## Kassab Travel Center Project

# Appendix M Response to Comments

### INITIAL STUDY/MITIGATED NEGATIVE DECLARATION

**September 2019**

**Figure 3: Site Plan**  
 Source: Karaki Western States Engineering

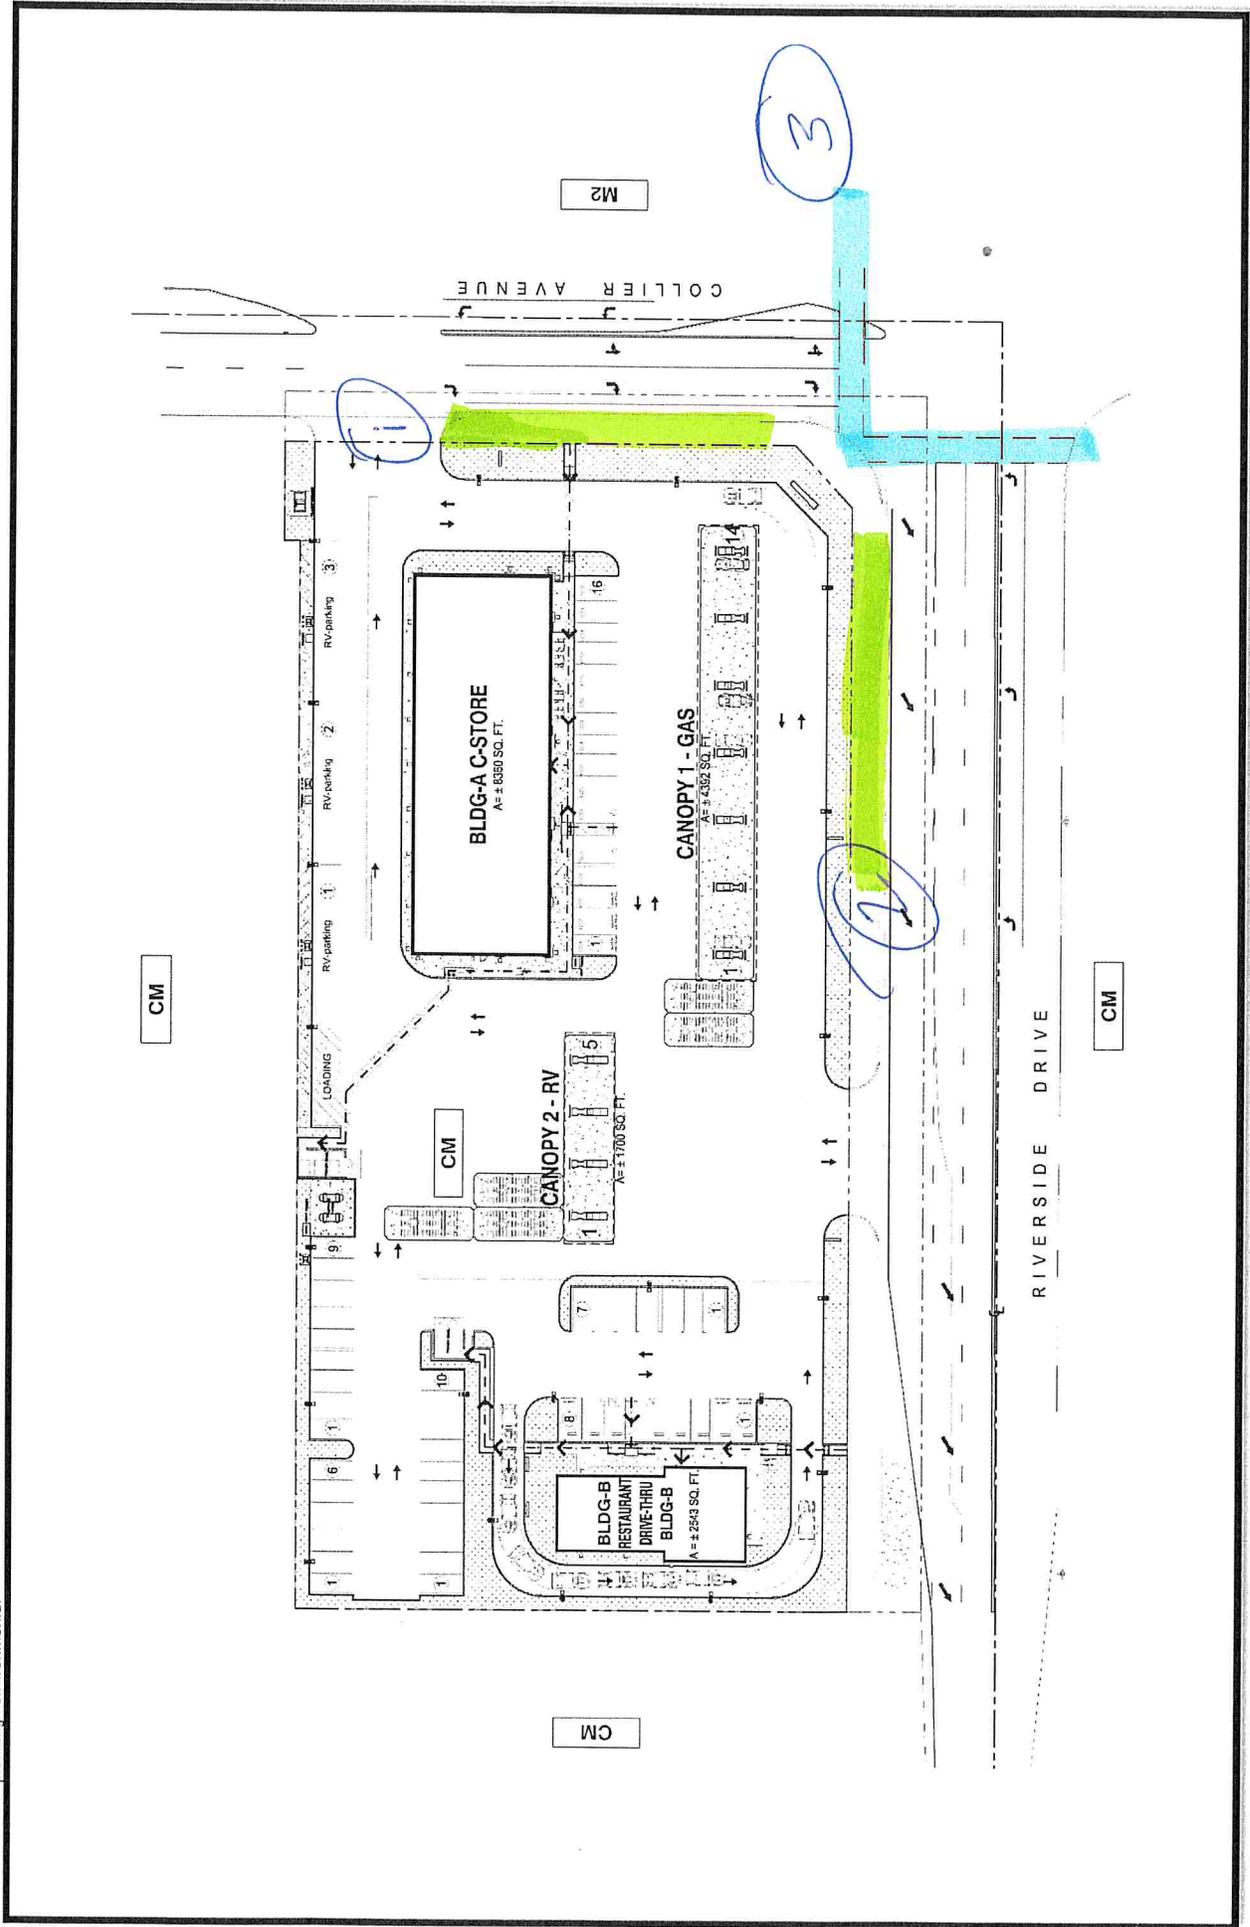
1. ADA compliant connected Sidewalk on Collier Ave before Riverside Dr (see attachment). **A-1**  
Can the City remove the back of the right turn lane to allow RTA to place a bus stop here farside of the development's driveway.
2. ADA compliant connected sidewalk on Riverside Ave after Collier Ave (see attachment). **A-2**  
RTA plans to locate a new bus stop here if the stop requested in item 1 is not possible.
3. A formalized/marked crosswalk at the intersection of Collier Ave and Riverside Dr (see attachment). **A-3**

6. (Figure 3: Site Plan) – The site plan doesn't illustrate the provision of curb ramps at the driveways. Be sure to include the curb ramps in the Street Improvement Plans prior to encroachment permit submittal. E-6

9. (Figure 3: Site Plan) – Per Section 206.3 of Caltrans' Highway Design Manual, the taper length is shorter than required and will need to be increased to accommodate the two-lane drop. The HDM was recently updated on December 14, 2018 and can be found at the following link: E-9

The Applicant and the City have previously coordinated with RTA regarding bus stop location, which is identified on westbound Riverside Drive on the far side of the development’s driveway. Figure 6: *Right-of-Way Improvements*, has been updated to clearly identify the proposed bus stop pad.

- A-3.** RTA requested a marked crosswalk at the intersection of Collier Avenue and Riverside Drive. Intersection improvements, as shown in Figure 6: *Right-of-Way Improvements*, would include a marked crosswalk at the intersection of Collier Avenue and Riverside Drive.
